URBAN DESIGN BRIEF

# Odayanhaway 30 Cleary Ave.

Project # : 2314

Phase 3 Resubmission: May 30, 2024

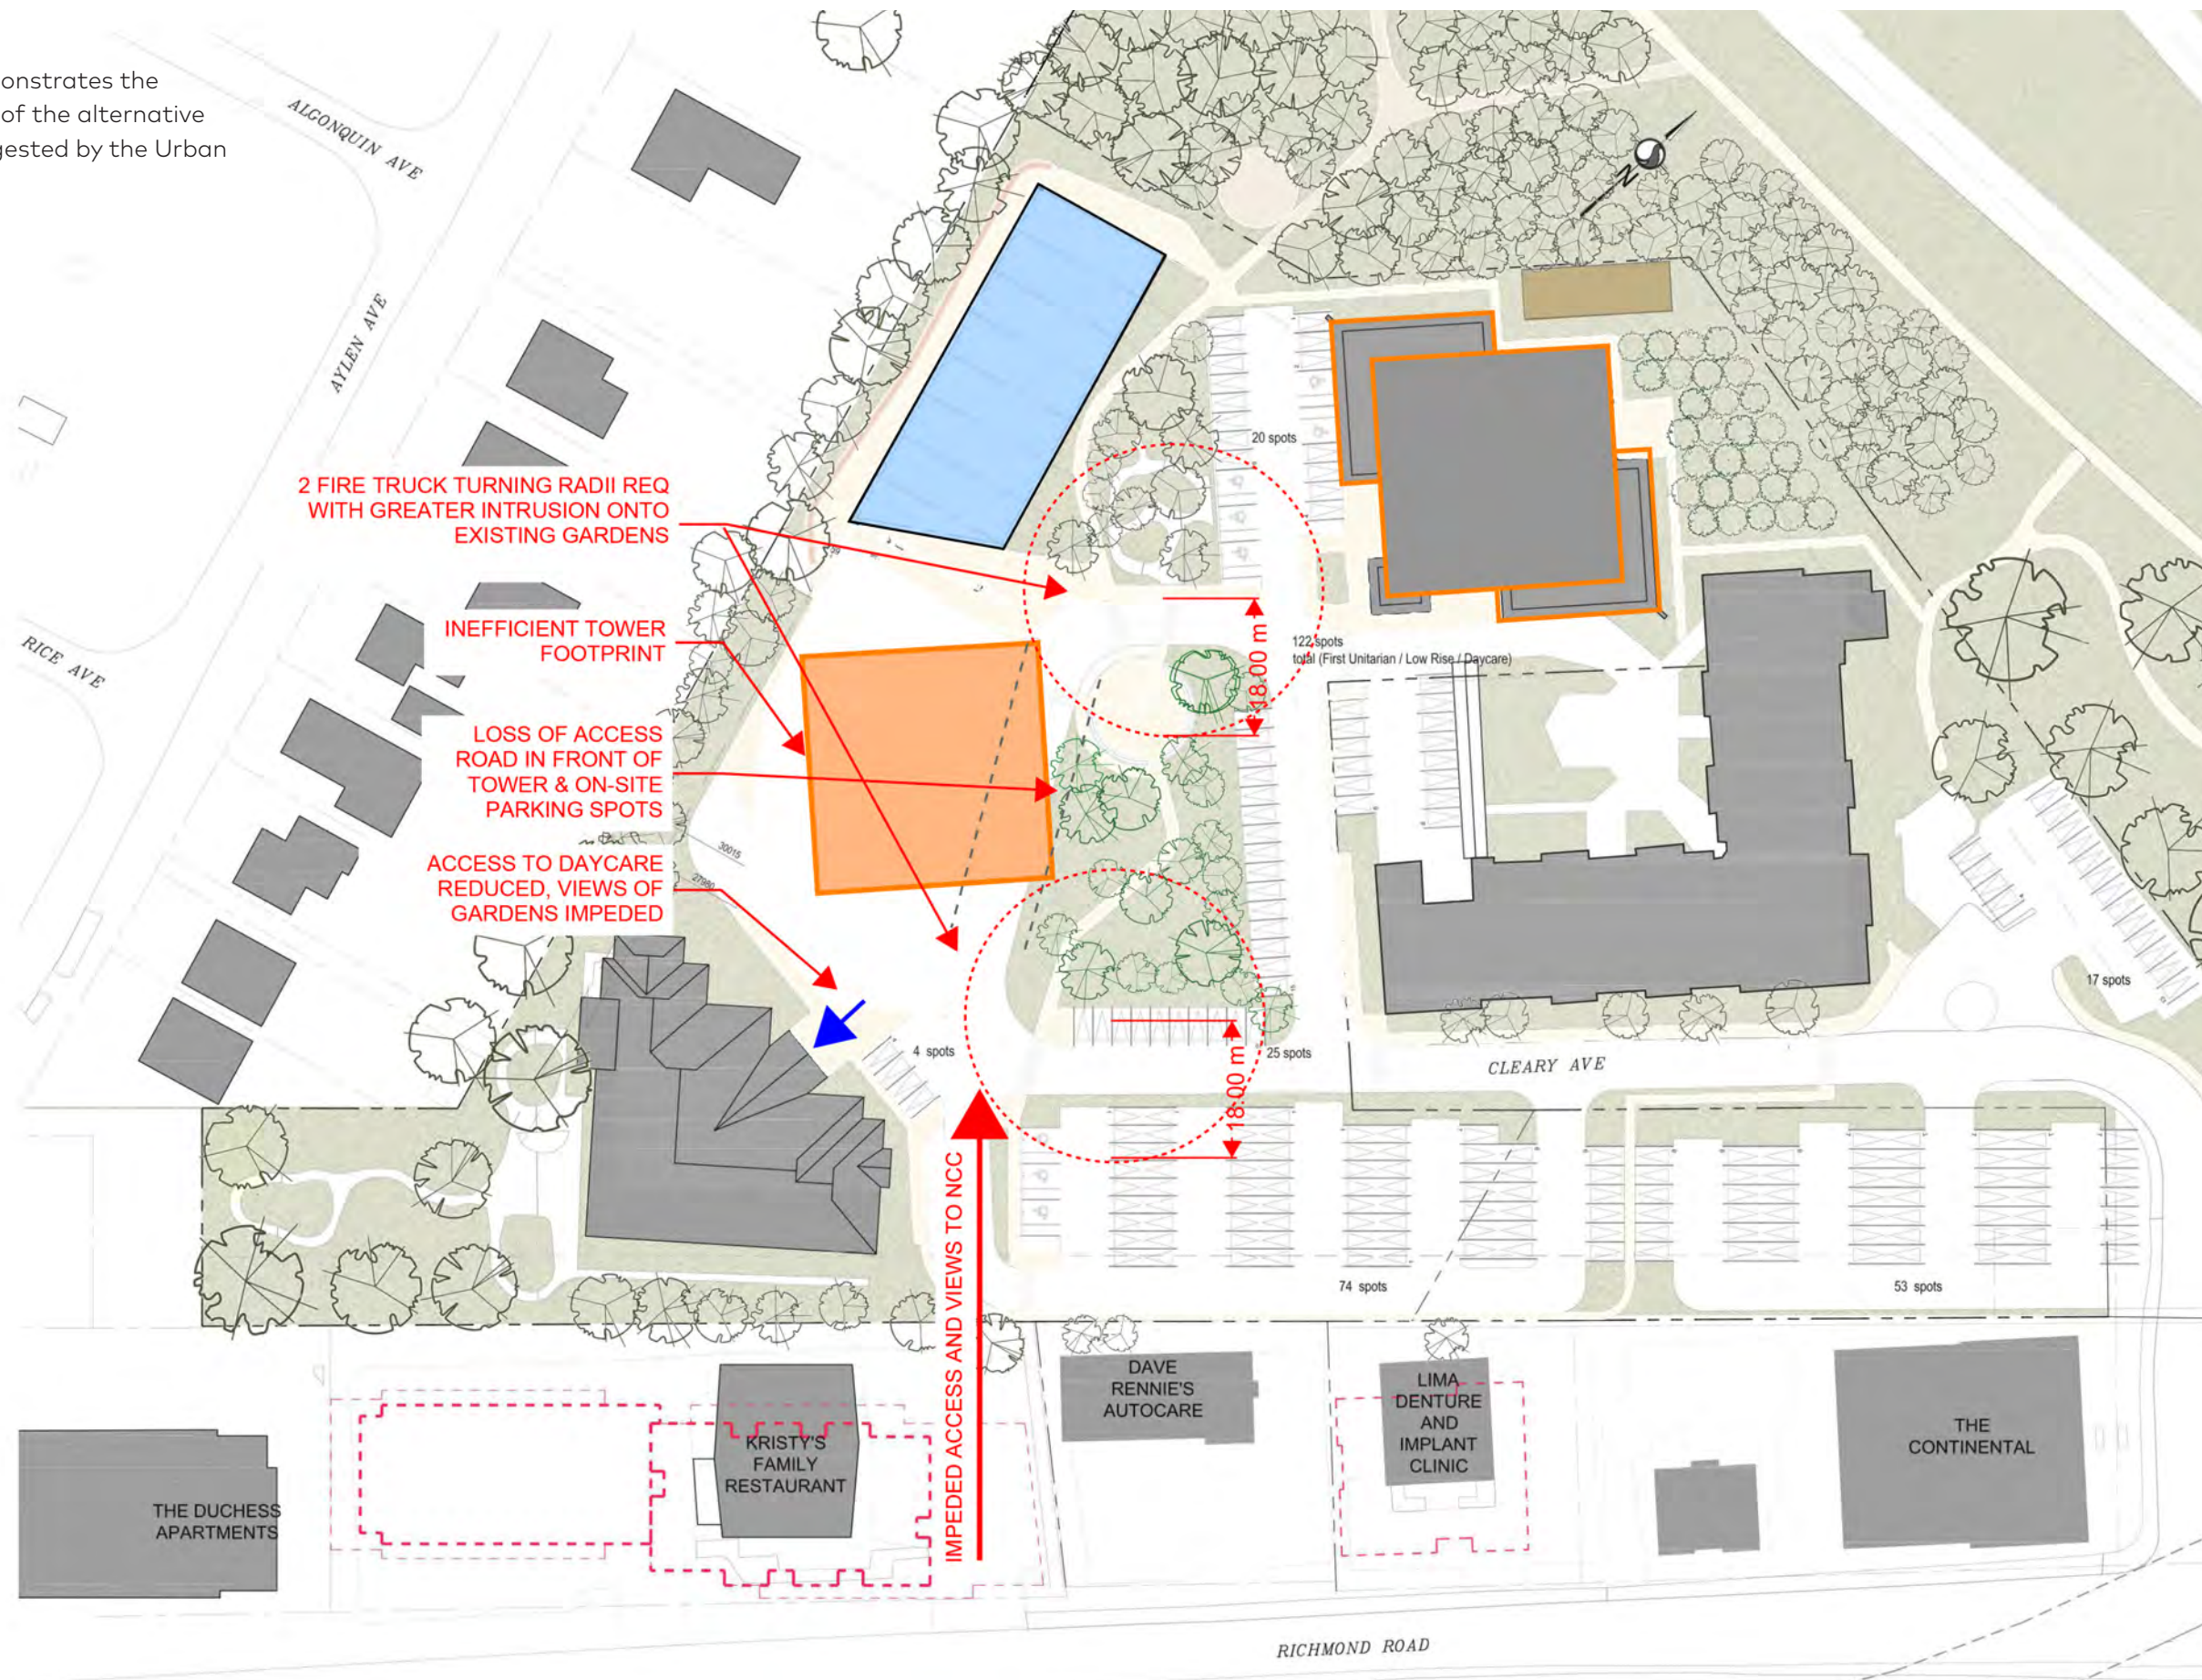
The following diagram demonstrates the exploration and limitations of the alternative site plan arrangement suggested by the Urban Design Review Panel.

**Noted. A similar diagram is in the Design Brief with points for why this orientation does not suit the site. As per previous comment, we fully believe proposal as presented is the most appropriate.**
